NNF22

Response to RSP's response to ExA4WQ Ns.4.3
Noise contours produced by the Civil Aviation Authority for
No Night Flights

5th July 2019

Comparison between ANCON and another noise model's default profile for Boeing 767

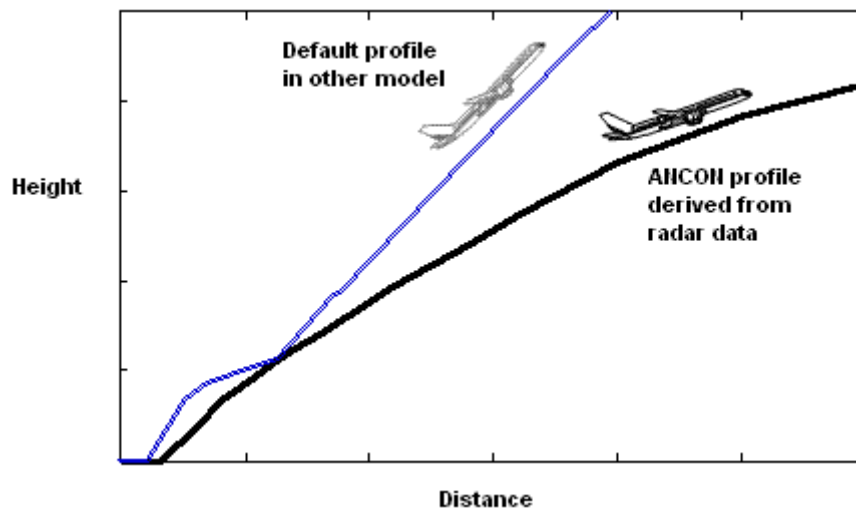
18. Key points to take from this explanation by the CAA is that the ANCON flight profiles may differ significantly from the default profiles in some noise models. The diagram above which compares the ANCON-derived profile for a B767 to another noise model's default profile for the same aircraft, would have a significant impact on the assessment of the actual noise nuisance that would be experienced on the ground. The default profile shows the departing plane reaching a greater height much sooner than the profile generated by the CAA. The CAA's profile captures the reality of a longer, lower, and therefore noisier, take off. It is the CAA's model that will be used to determine eventual flight paths should this DCO be awarded. The CAA's model is therefore to be preferred.
